PLANNING COMMISSION AGENDA

- 5) **PUBLIC HEARINGS & SUBSEQUENT BOARD ACTION**
- 6) **OLD BUSINESS**
- 7) **REPORTS AND RECOMMENDATIONS/NEW BUSINESS**
 - A. **1154 WEST MICHIGAN AVE SITE DEVELOPMENT PLANS**

TO: Planning Commission
FROM: Marcia Strange, Director of Community Development
DATE: February 20, 2025
SUBJECT: **1154 WEST MICHIGAN AVE SITE DEVELOPMENT PLANS**

SPRINGHILL SUITES
by MARRIOTT
MARRIOTT JOB #XXXX
MARSHALL, MI
A NEW 101 ROOM HOTEL

SHEET NUMBER
C2.1

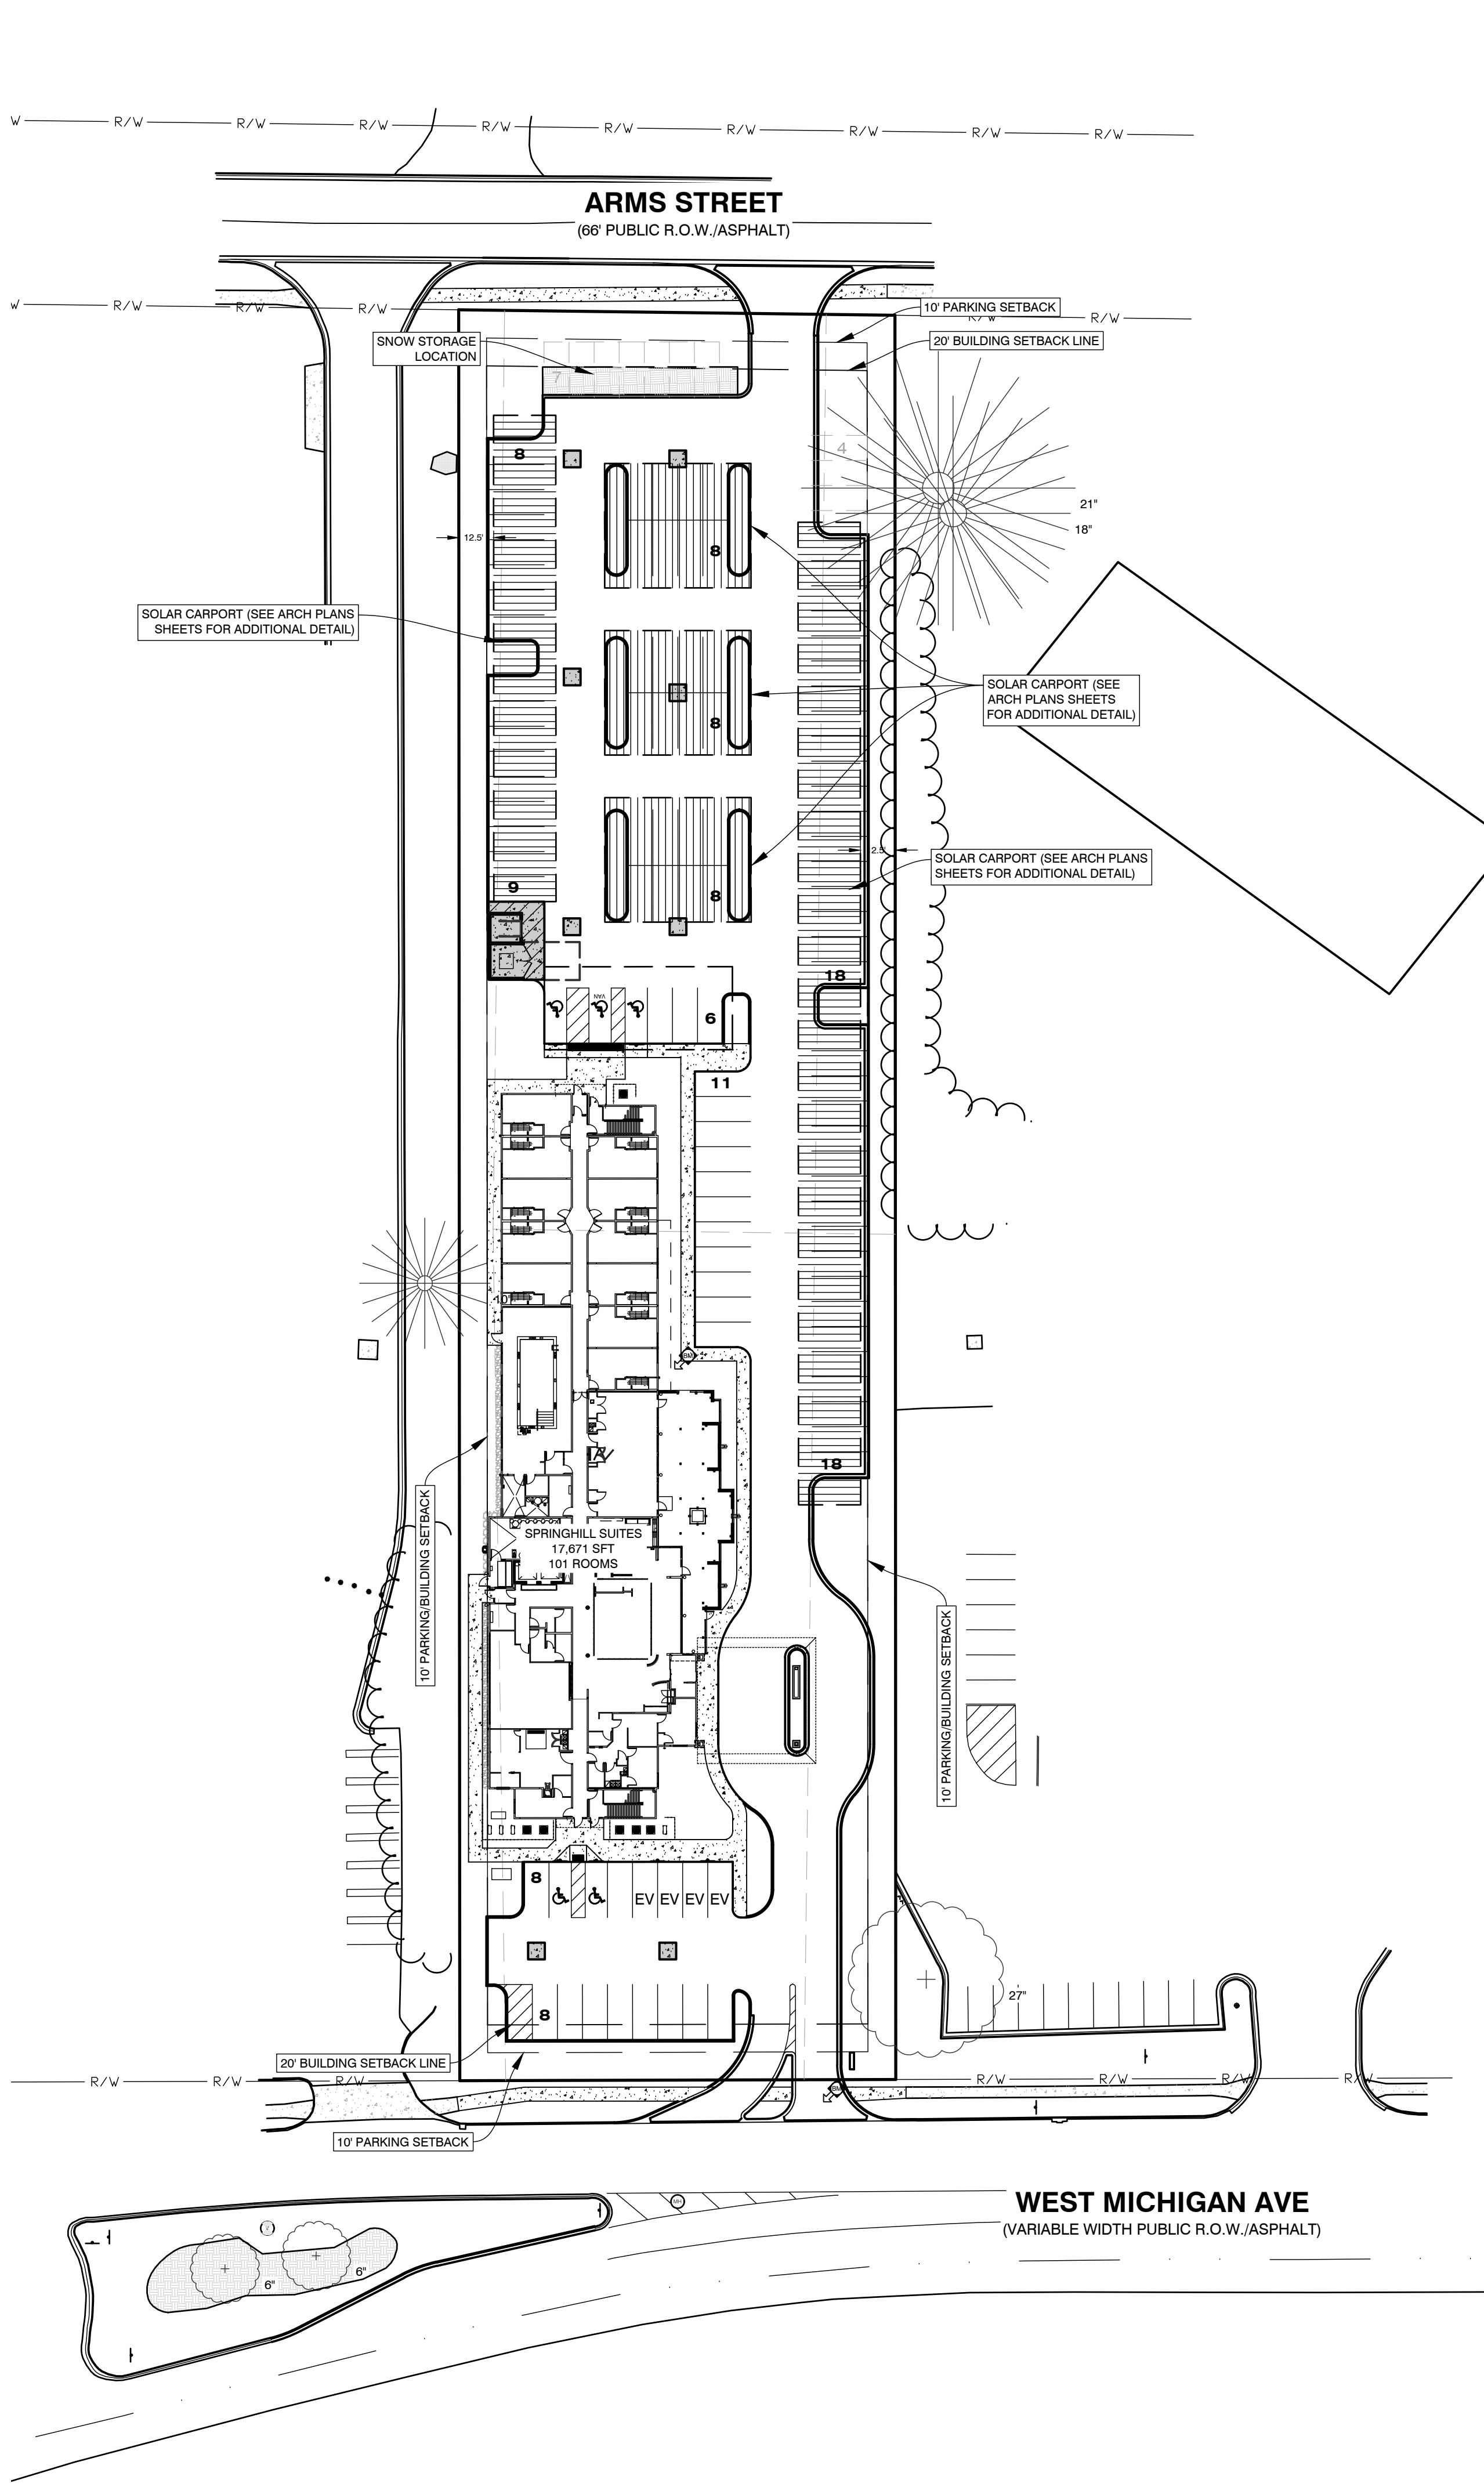
The setback requirements are mostly based on the accessory building setbacks (3.1.10), but there is a 50' setback from the adjacent residential to the East at the North end of the property required by the solar section (4.53 F).

Side setbacks must be at least 10' and add up to 25' (3.1.10 D) The front setback is not an issue for the panels.

Measuring the setback distance of an accessory building is typically to the wall from the property line. Because there is no wall, it was decided that the columns could serve as the wall location.

Height limit is based on accessory structure requirements (4.53 G) in the B-4 Regional Commercial Zone (and is measured as the mid-height of the slope). A 25' (2-story) height is allowed in areas where 50% of adjacent buildings (200' radius) are at least 2 story. The proposed solar panels are within the limits of these requirements.

Area of solar panel is limited to 1/2 acre per (4.53.2 H.ii) and the total structure area is just under 21,000 sf (0.48 acre).

The Fire Department's review of the plan brought up concerns about catching the corner of a panel when the fire truck accesses the North side of the building. This will be adjusted prior to construction documents to accommodate the required turning radius for the fire truck, and the final panel angles will be reviewed with the boom extension angle of the fire truck.

Confirmation of final column locations be required to stay beyond setback, and solar panels to extend into setback but not beyond the associated curb.

- Solar Items:
 - We will provide updated solar details for Fire Department coordination and provide along with other revised drawings upon approval.
- Landscaping Items:

Landscape Plan

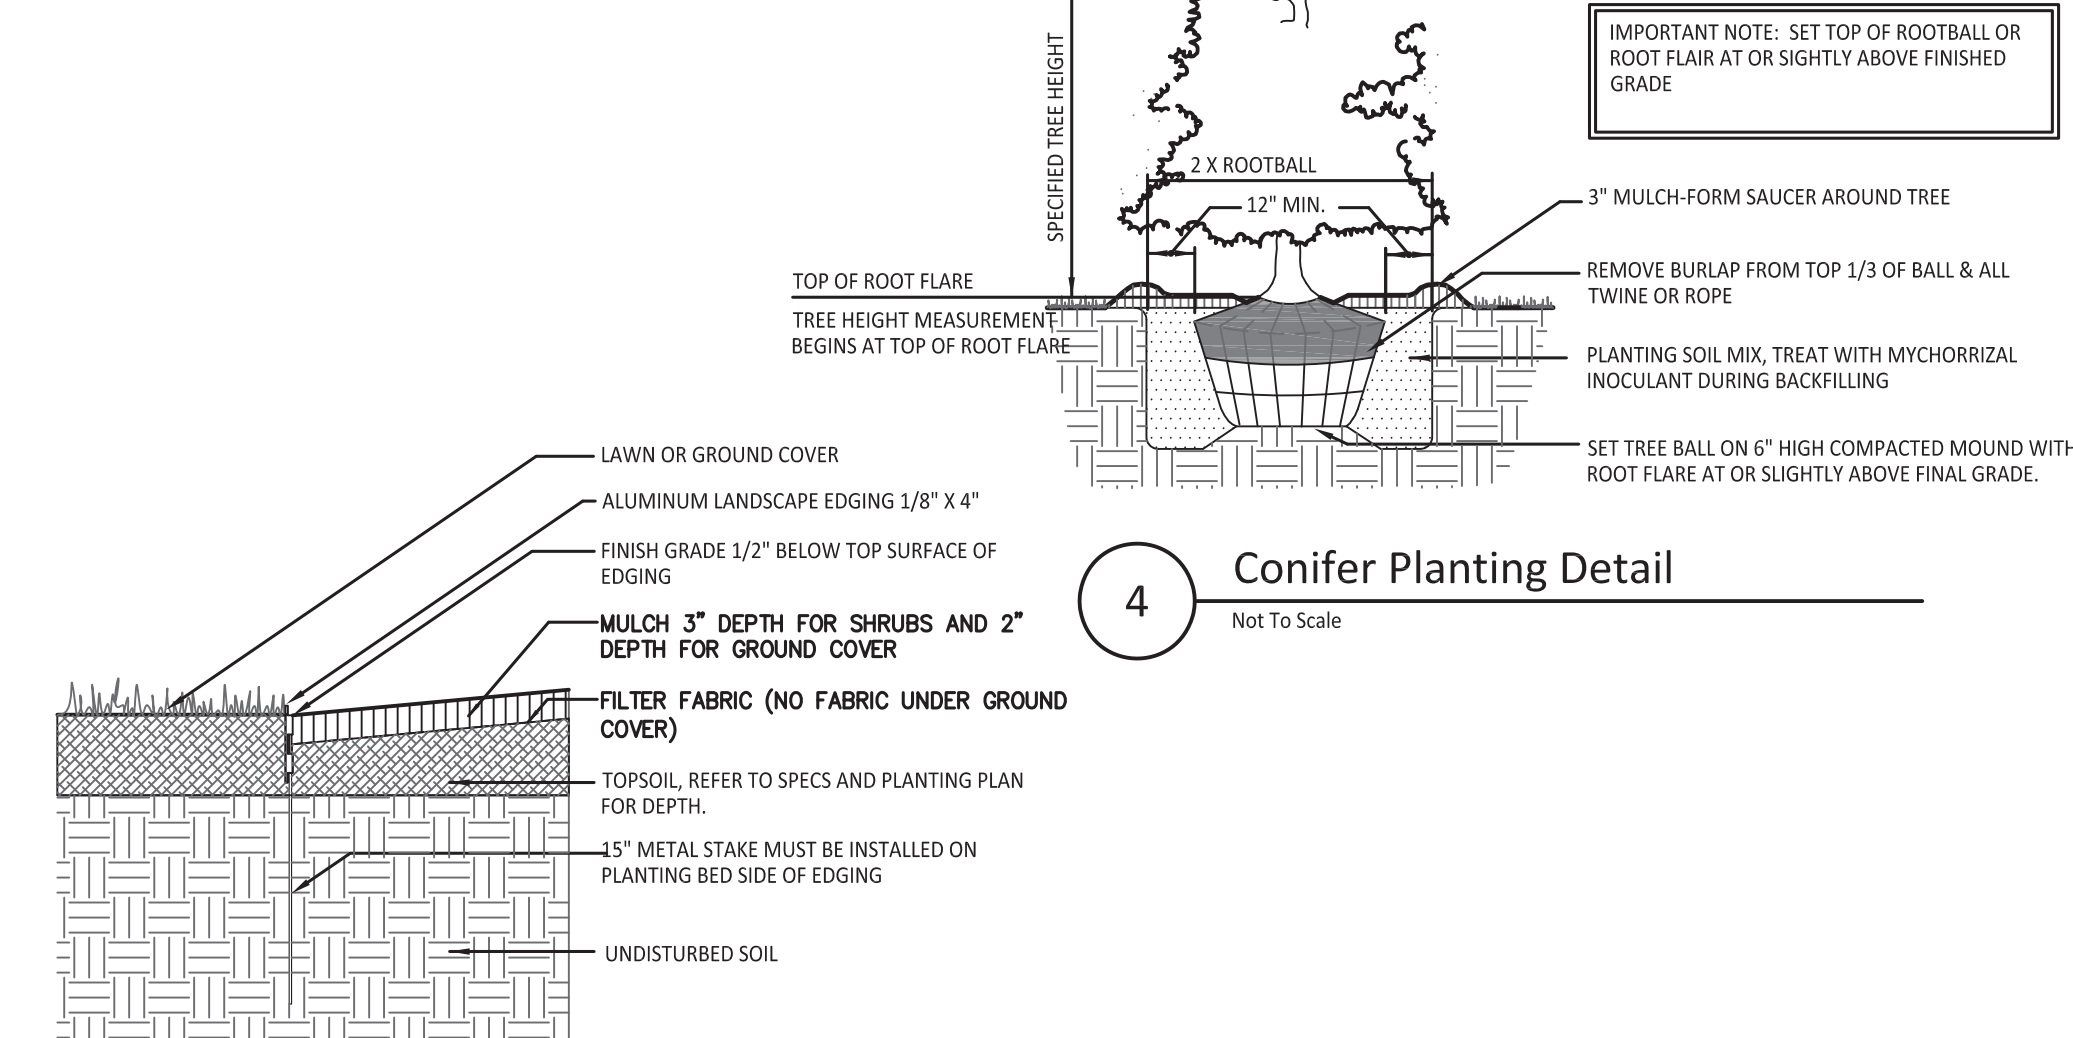
- We will plan to revise the plan to provide evergreen trees in lieu of deciduous trees along the East property adjacent to the apartment building property.

- We will revise the caliper of the deciduous tree from 2" caliper to 2.5" caliper.
 - We will provide the final planting numbers in the planting schedule table with the plan.

- We will review and comply with the zoning ordinance as it relates to required shrub sizes at time of planting. The plans will update this.
 - These minor revisions will be updated on the landscape plan after the PC meeting to confirm we account for all necessary revisions in one round of updates.
